TOWN OF ASTATULA
Planning & Zoning Commission Meeting
Thursday, May 22, 2025 – 6:00 PM
Astatula Town Hall
25009 County Road 561 | Astatula, FL 34705

**RE: Mack Concrete Expansion
Halff # 059233.001
Request for Additional Information #2 - Major Site Plan**

CONSTRUCTION PLANS
FOR
MACK CONCRETE
156,000 SF EXPANSION

Project Name Mack Concrete expansion
Project Phase Site Plan only not full civil plans
Discipline: Engineering
Reviewed by: Dana S Johnson, P.E.
Review Date: 04/22/2025
Contact: dajohnson@cgasolutions.com , 954-766-2744
Review: ☐ 1st Rev. ☐ 2nd Rev. ☒ 3rd Rev.

PROJECT NO. : 59233.001
ISSUED: XXXX
DRAWN BY: RON
CHECKED BY: CCH
SCALE: 1"=100'
SHEET TITLE:
EXISTING CONDITIONS

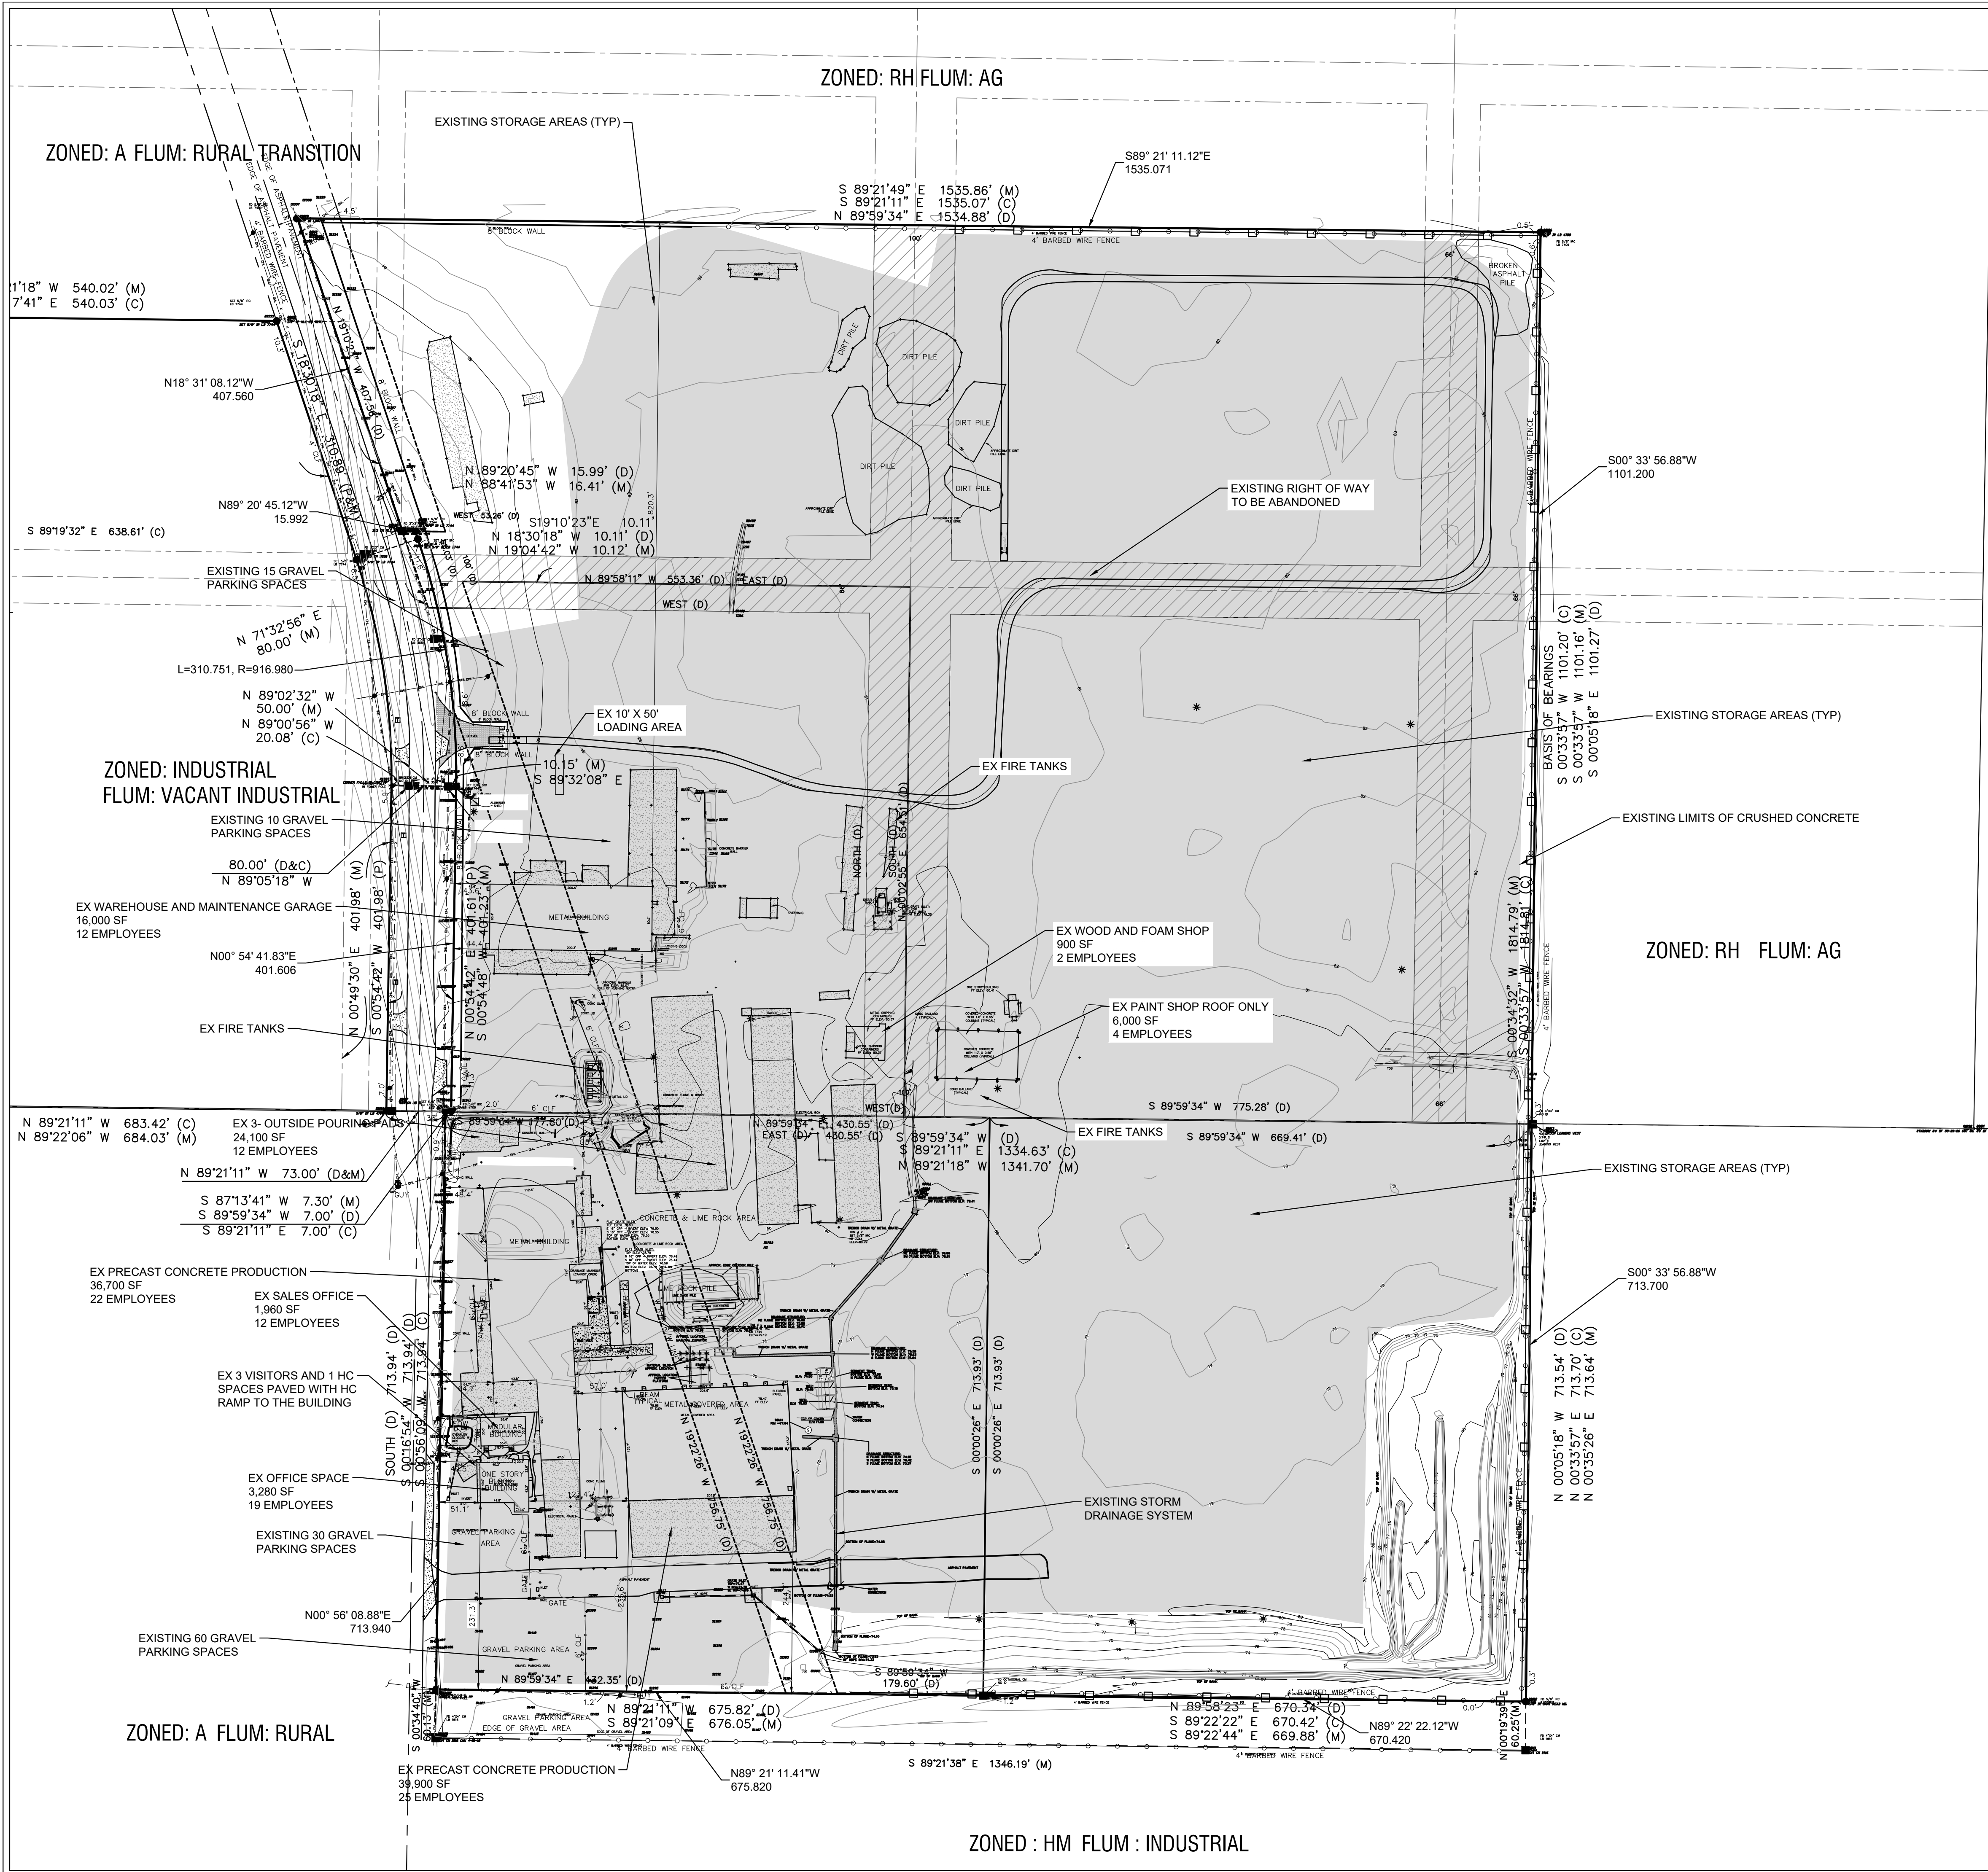
** PENDING. For number 13 thru 15, the updated site plan did not include any water and sewer information for the new building. Please explain if there will be none or if it will be via private well and private septic. If on a well and septic, please delineate and label the well and septic drain field on the plans.

Response: There are existing fire tanks on site for fire protection. See Sheet EX-1 for location of fire tanks.

****Addressed. Fire tanks were labeled on the site plan.****

**EROSION CONTROL &
DEMOLITION PLAN**

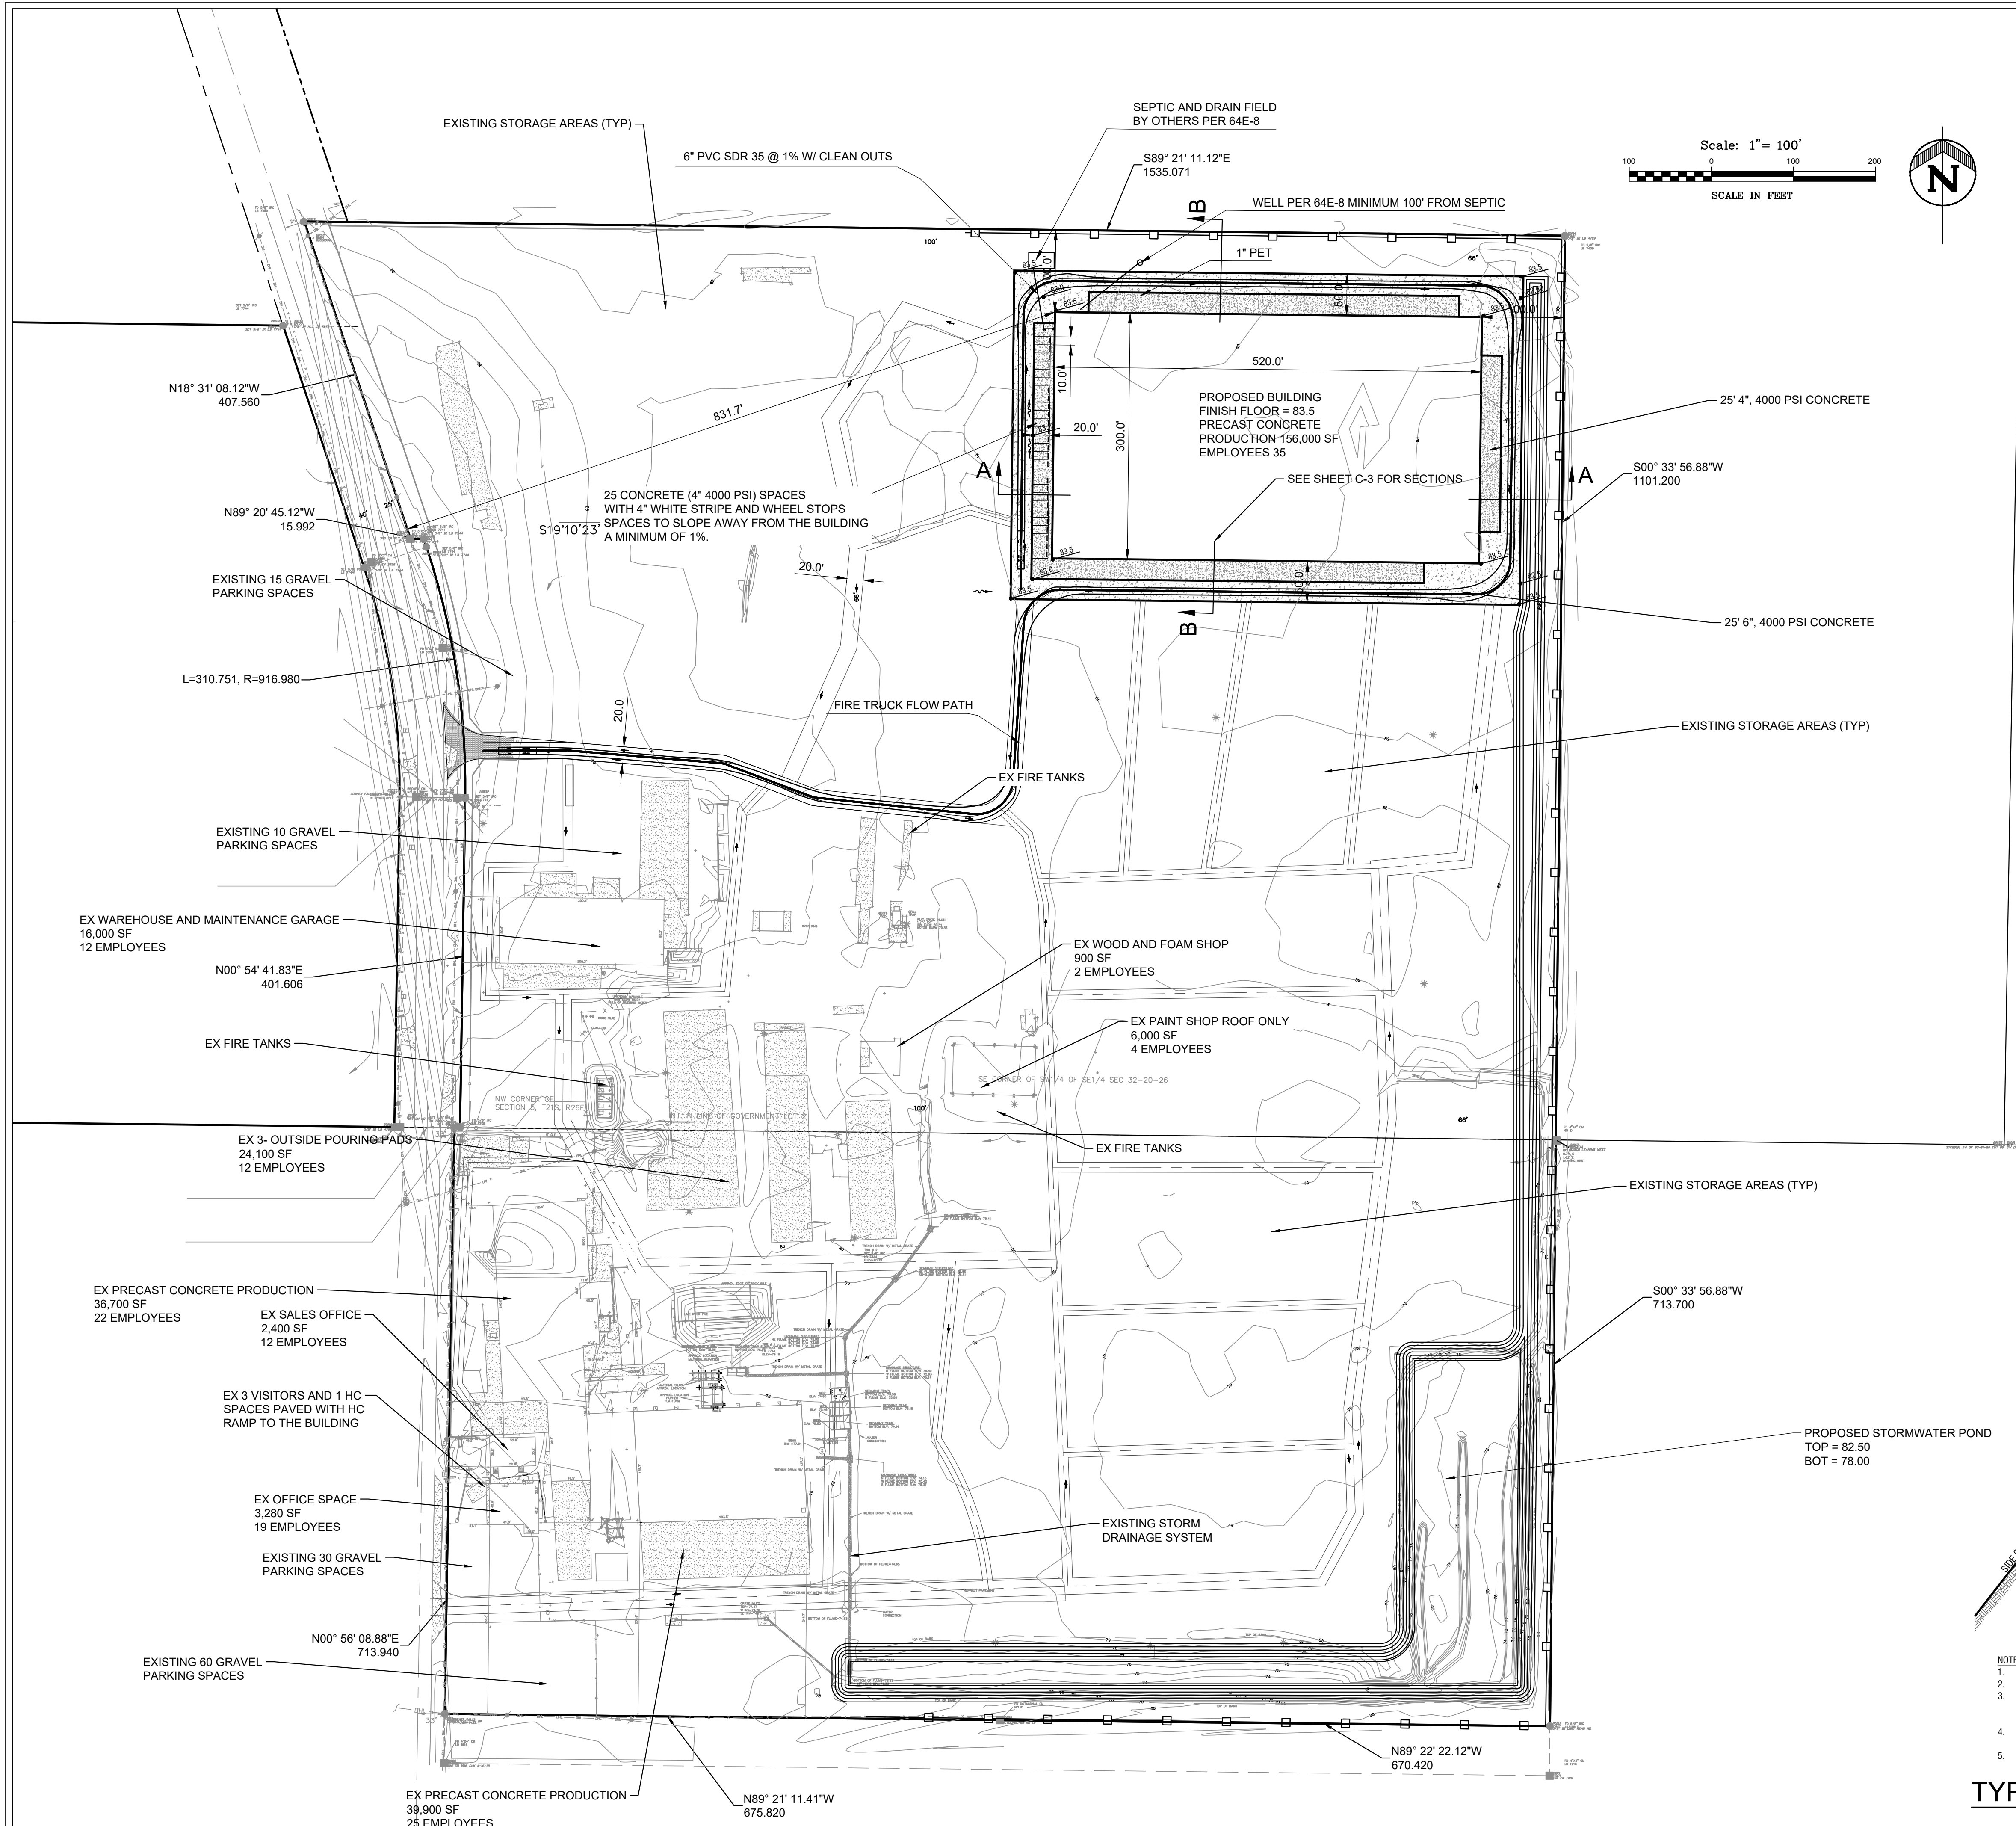
** PENDING. RTC indicates no run-off can leave the site due to the concrete wall that surrounds the site. However, a SWPPP will be required which must also address dust control and access control to keep sediment off public roads. The SWPPP will be required with the full civil plan submittal and approved prior to issuance of a building permit

** PENDING. RTC indicates not applicable, however these detail will be applicable since this site will be disturbing more than 1 acre and will need to control dust and access to the site to reduce erosion.

Response: See Sheet C-1 for Erosion Control and Demolition Plan. The site contractor will obtain NPDES permit prior to construction

Response: See Sheet C-1 for details and notes

****Addressed. EOR is showing 1.03 acres disturbed and erosion control details and notes. A NPDES permit is required and contractor to provide a copy of the NOI and SWPPP plan prior to permit issuance.**

SITE PLAN

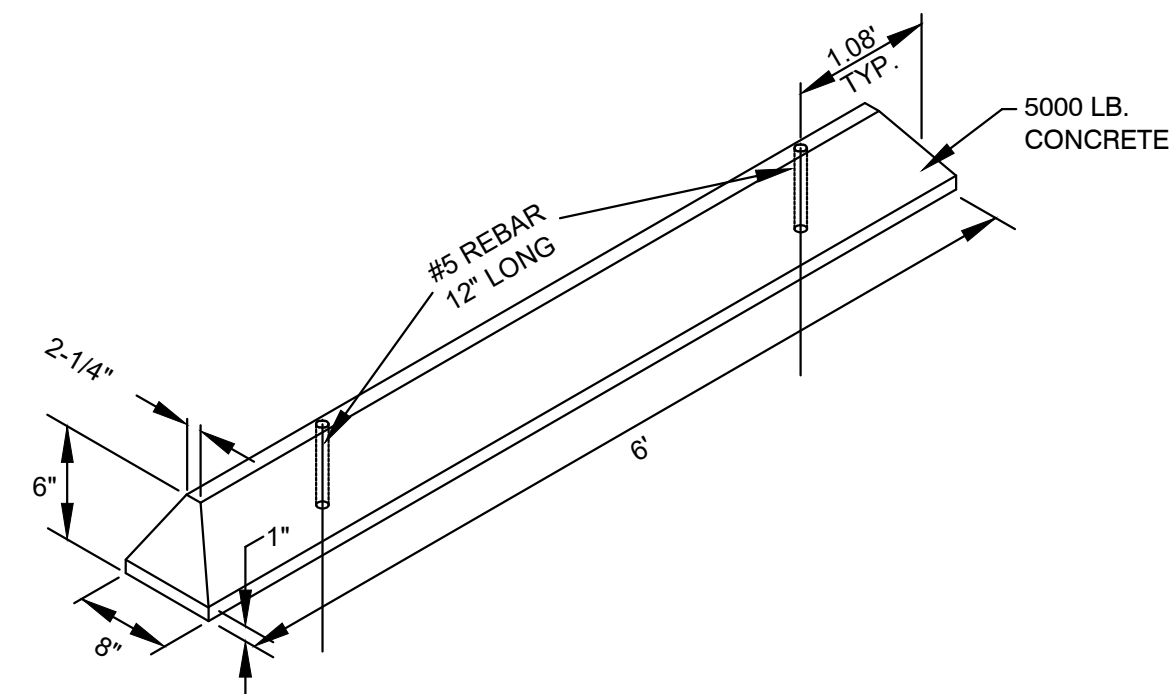
**** PENDING.** Parking calculations do not match the requirements of Section 59-7.5.2. It appears that industrial manufacturing is 1 space per 500 SF GFA, Warehouse is 1 space per 1,000 SF GFA, General office is 1 space per 200 SF GFA, and loading is 1 space per 10,000 SF GFA. Also provide the size of the loading space and delineate its location on the plan. Please update the parking calculations using the numbers outlined in the Astatula ordinance.

**** PENDING.** Parking calculations did not summarize the provided or existing ADA spaces. List the existing provided ADA spaces. Provide a more detailed parking plan that shows the existing parking space locations and dimensions including the driving aisle dimensions. This can be done on an aerial image with dimensions to demonstrate the existing parking layout present. Reviewer understands that much of the parking is gravel, but more information will be required to demonstrate this projects compliance with the ordinance as it relates to the required ADA parking.

** PENDING. For number 13 thru 15, the updated site plan did not include any water and sewer information for the new building. Please explain if there will be none or if it will be via private well and private septic. If on a well and septic, please delineate and label the well and septic drain field on the plans.

** PENDING. For number 13 thru 15, the updated site plan did not include any water and sewer information for the new building. Please explain if there will be none or if it will be via private well and private septic. If on a well and septic, please delineate and label the well and septic drain field on the plans.

Response: Parking criteria has been added to Sheet C-2 and parking variance is being requested from the Town Council. Loading space is shown on Sheet C-1 and loading variance is being requested.

Response: The existing office which is open to the public has 1 handicap space and ramp to the building. The existing visitor parking and handicap space is shown on revised Sheet C-1.

Response: See Sheet C-2 for location of well

Response: See Sheet C-2 for location of septic tank

****Addressed.** 1 Accessible parking space and accessible ramp is located within the paved parking area for the office, which is the only part of the business open to the general public. A note was provided indicating that the Owner will add additional accessible spaces as needed behind the gate for employees when the need arises. ******

****Addressed.** Location of Well and Septic are now delineated on the site plan and are to be permitted according to FAC 64E-8 and 64E-6. ******
